UPPER TRISHULI-1 HEP (216MW)

REVIEW NOTE

Contractor	**Doosan Enerbility**		
Title of the Document	Reinforcement Drawings (Bay-01) Plans & Elevations below 909.2 amsl & Reply Comments		
Document No.	UT1-C-340-CVL-DG-61002 & RC-0383	Revision	0B
Date of Documents	16.01.2024	Received Date	16.01.2024
Transmittal Form No.	UT1-HEP-DHI-D-1190		
Previous Review Date/Status	02.10.2023/RR	Prev. Review Note No.	RN-0867
Review Note No.	**RN-1135**	**Present Review Date**	**14.02.2024**
		Present Review Status	**RR**

Figure 8-12: Plan view at turbine floor level

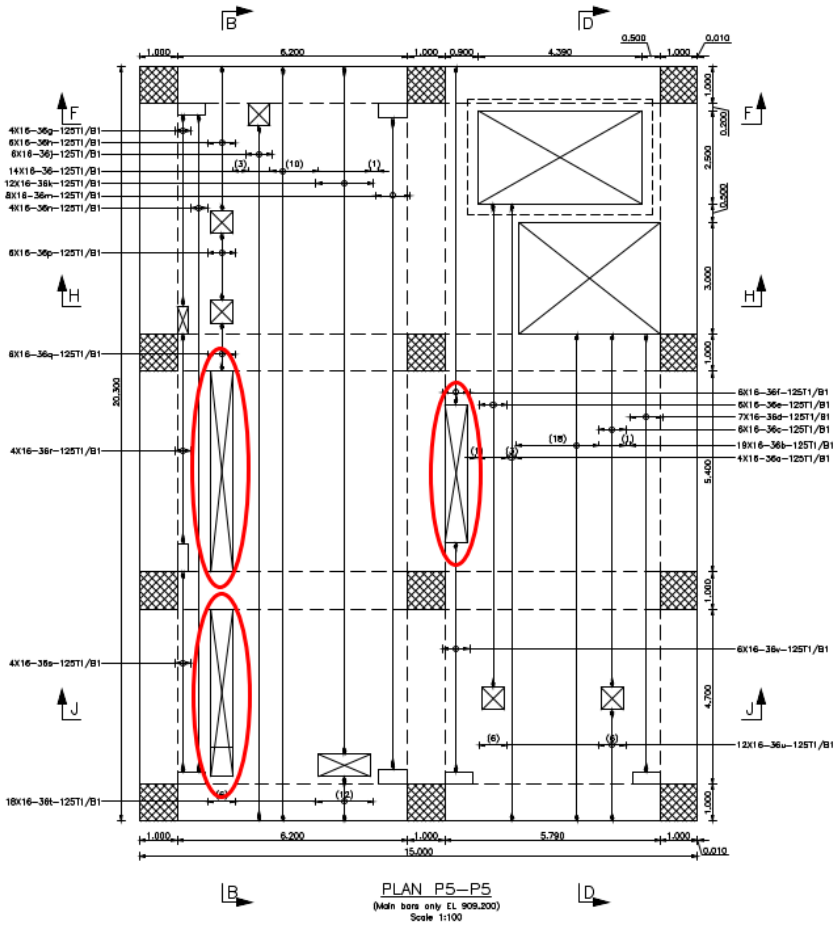
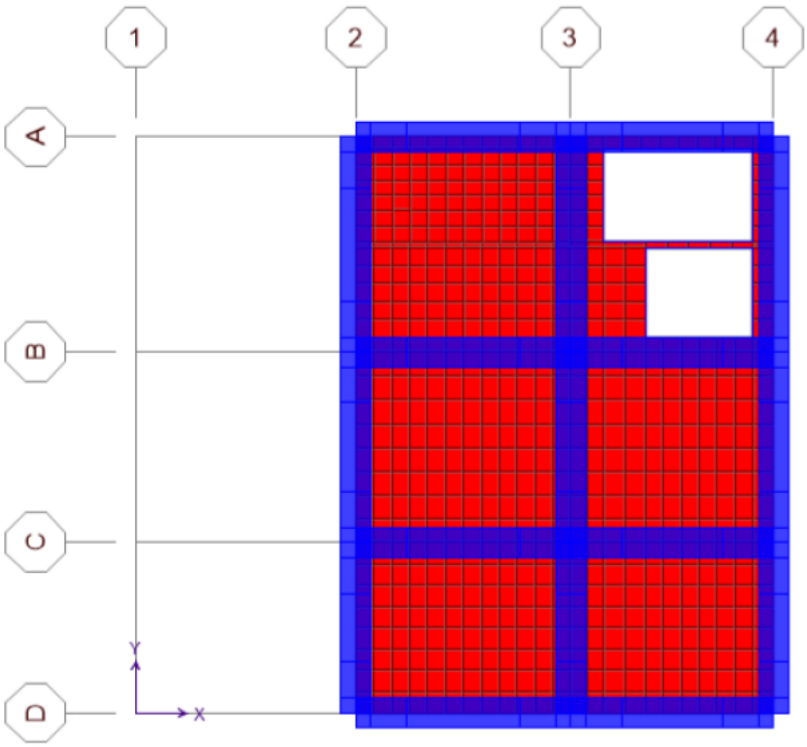
- Openings presented in the reinforcement drawings of the Bay 01 turbine slab (909.2amsl) are not considered in the structural analysis report (see figures below). Although small openings if not previously foreseen can be neglected in the structural analysis bigger openings that are changing the structural system of the slab (the slab is supported only on three sides instead of four) cannot be ignored. Redistribution of the load would mean that a portion of the structural concrete left will be overloaded. This is not foreseen in the structural analysis. The structural analysis should be updated to consider the presented openings. Slabs and beams around introduced big openings on the elevation 909.2amsl of the Bay 01 should be redesigned.

SECTION D–D
Scale 1:100

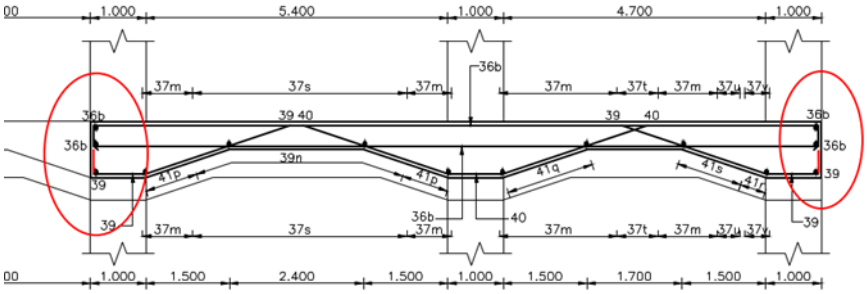
- Slab top and bottom bars in one direction are presented on the single drawing while top and bottom bars in the other (orthogonal) direction are presented on a separate drawing. This is unusual and not practical.
- Hooks should be foreseen for better anchorage of the bars.

SECTION F–F
Scale 1:100

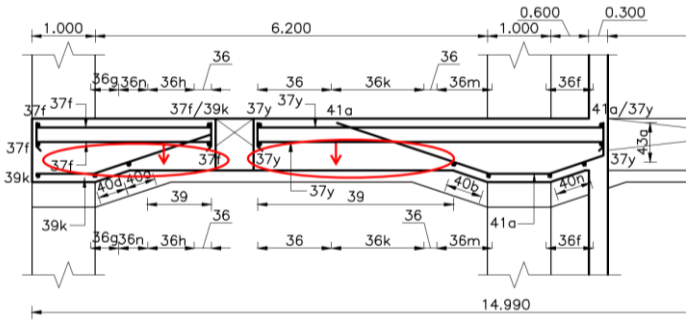
- The bottom zone of the slab is not reinforced on sections F-F and H-H see figures below.
